REQUEST FOR INFORMATION

No. 00058

TITLE: Cooling Tower Anchorage

PROJECT: BNL CCWF-II

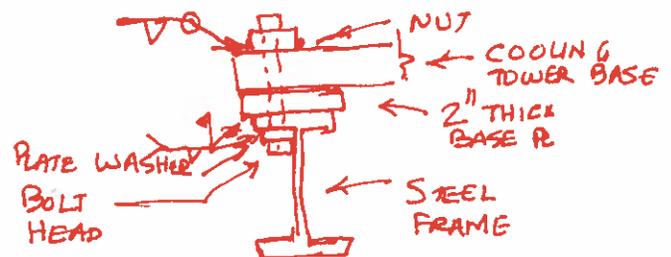
The tie down plates on the structural steel for the cooling tower do not align with the holes on the cooling tower flange in four (4) locations. We can remedy the situation by enlarging the holes in the plate, welding nuts onto the tower flange, and bolting from underneath the plate.

O.K. USE $\frac{1}{4}$ " THICK PLATE WASHER BETWEEN THE BOLT HEAD AND ENLARGED BOLT HOLE IN BEAM FLANGE AT BOTTOM. AFTER INSTALLATION OF TOWERS, WELD THE PLATE WASHER TO BEAM FLANGE AND BOLT HEAD TO PLATE WASHER.
